Addendum 2

Project Stadium New Press Box – Marlin ISD
Issued January 31st, 2024 by CEI Engineering Associates, Inc.
Proposal Opening February 6th, 2024 at 2:00 PM

E6.01

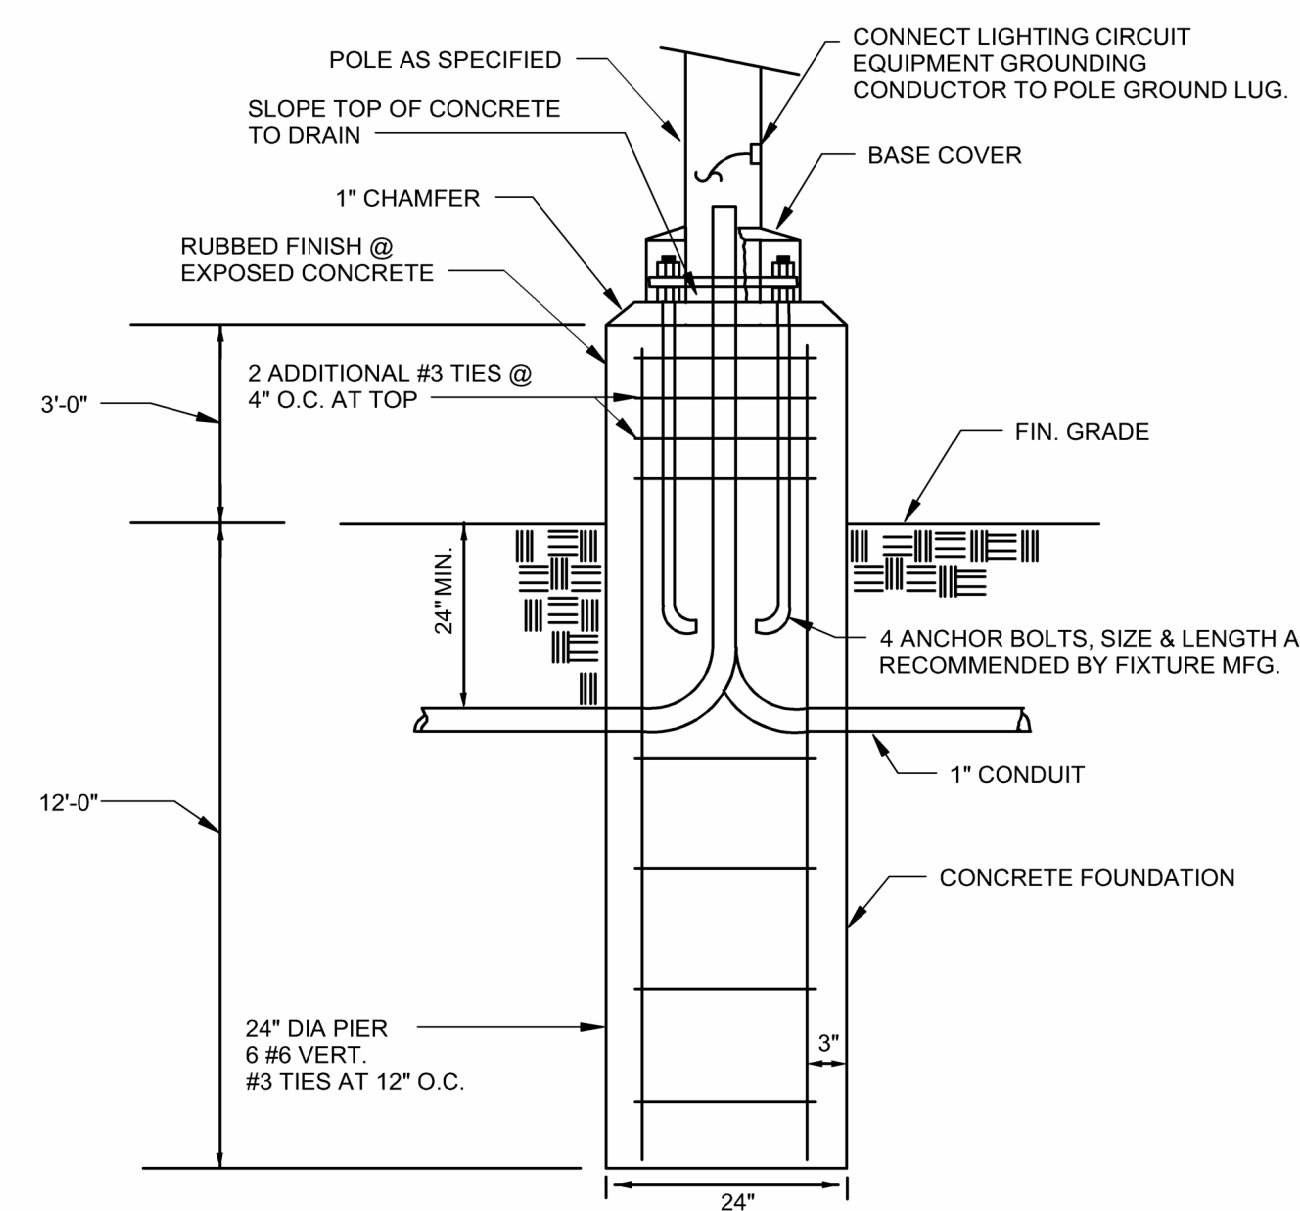
1. Sheet E6.01 – Electrical Site Plan has had its notes revised to clearly indicate the scope of this project.

- ELECTRICAL EQUIPMENT ON PIPE RACK, INCLUDING METER TRANSOCKET FOR ELECTRICAL UTILITY SERVICE, MAIN DISCONNECT SWITCH AND ELECTRICAL PANELBOARD 'MP' TO BE INSTALLED IN PHASE 1 ELECTRICAL SITE DRAWINGS. NOT IN THIS CONTRACT. SHOWN FOR REFERENCE ONLY.

- ELECTRICAL EQUIPMENT ON PIPE RACK, INCLUDING PANELBOARDS 'DH' AND 'DL' TO BE INSTALLED IN PHASE 1 ELECTRICAL SITE DRAWINGS. NOT IN THIS CONTRACT. SHOWN FOR REFERENCE ONLY.
